**ZAP COMMISSION SITE PLAN REVIEW SHEET
ENVIRONMENTAL VARIANCE
CONDITIONAL USE PERMIT
HCRO DEVELOPMENT BONUS**

CASE: SPC-2016-0055C **PLANNING COMMISSION DATE:** February 21, 2017

PROJECT NAME: Junior league Community Impact Center, District 10

CITY OF AUSTIN – DEVELOPMENT SERVICES DEPARTMENT
SITE PLAN APPLICATION – MASTER COMMENT REPORT

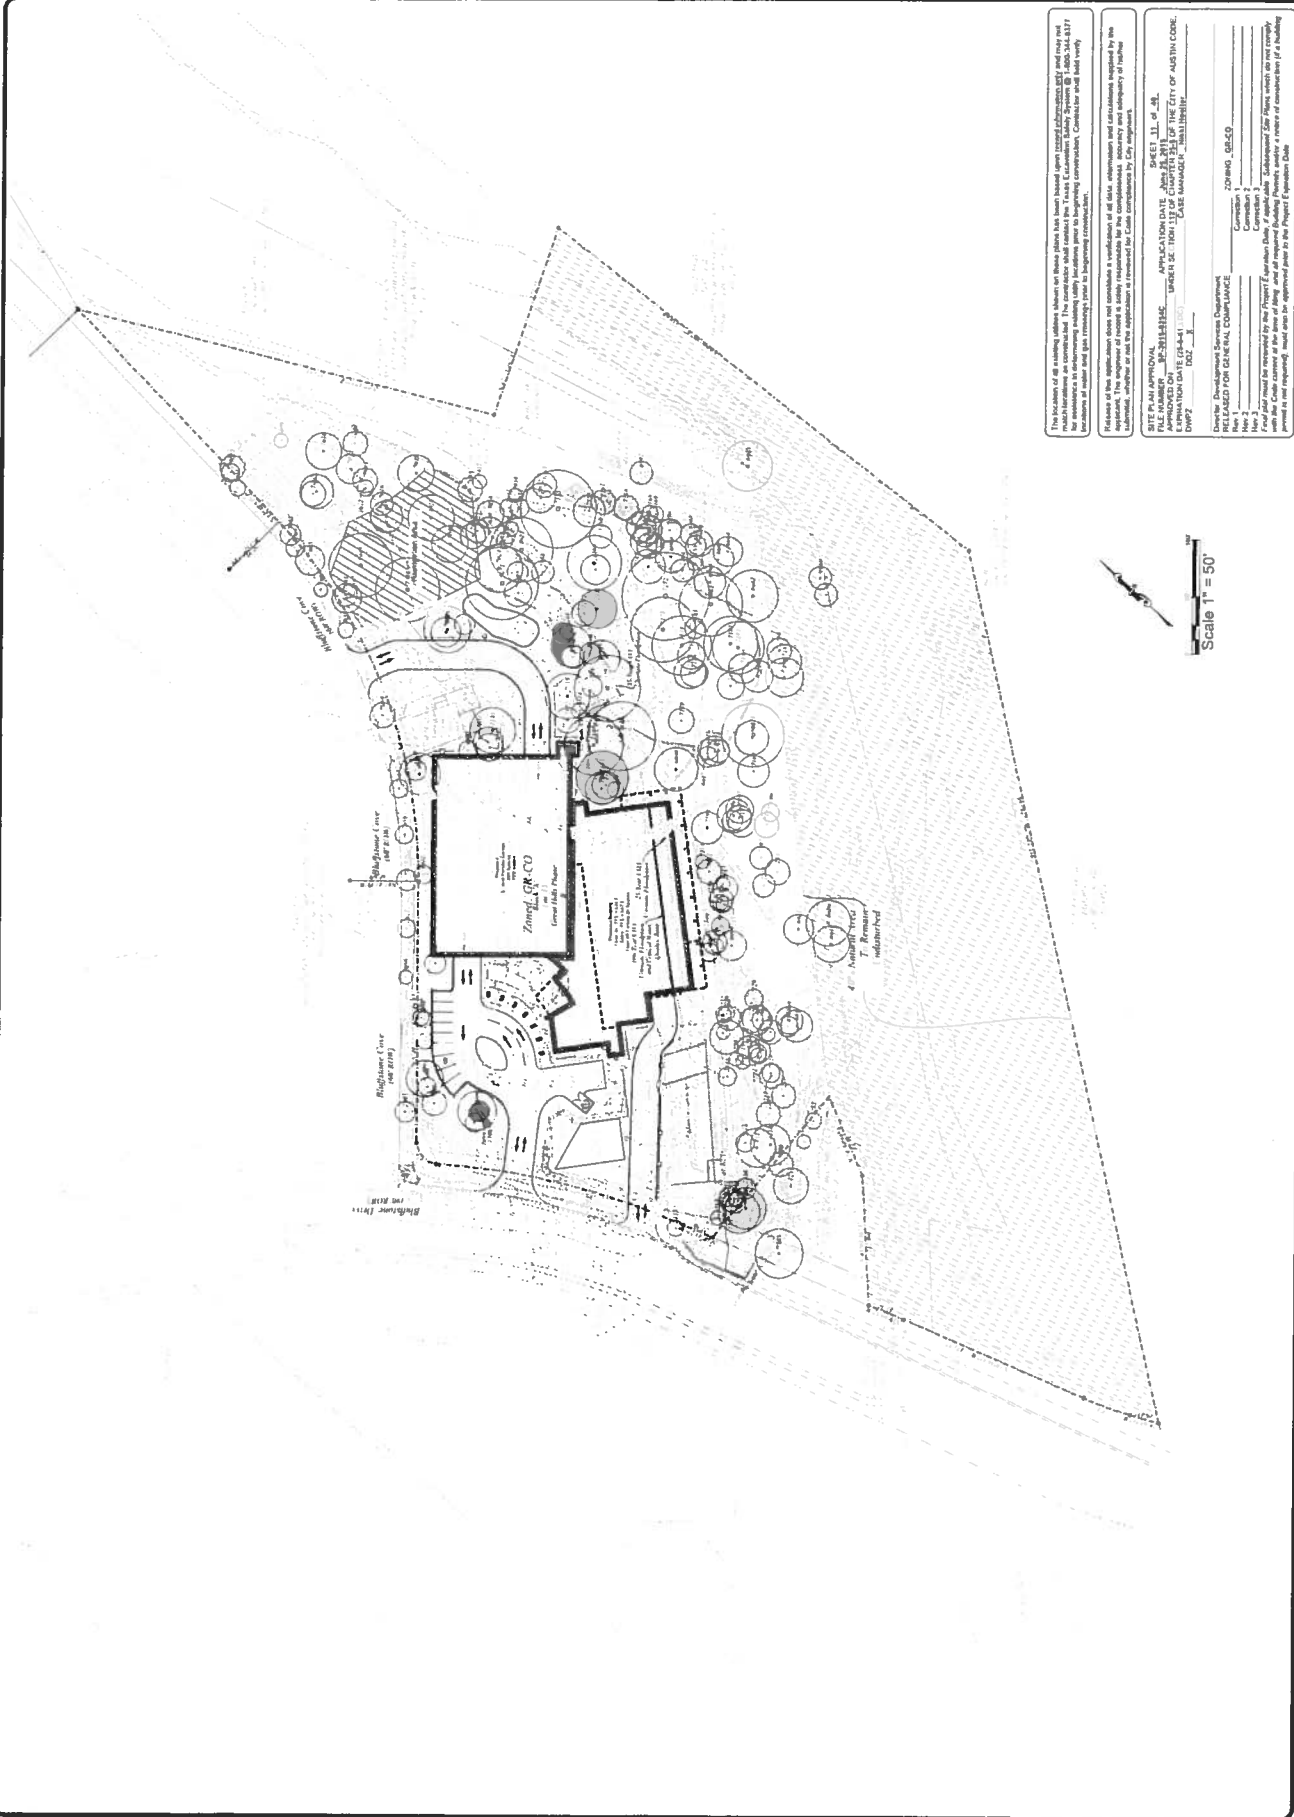
Red-lined comments have been provided on the plans submitted to the Development Service Department.
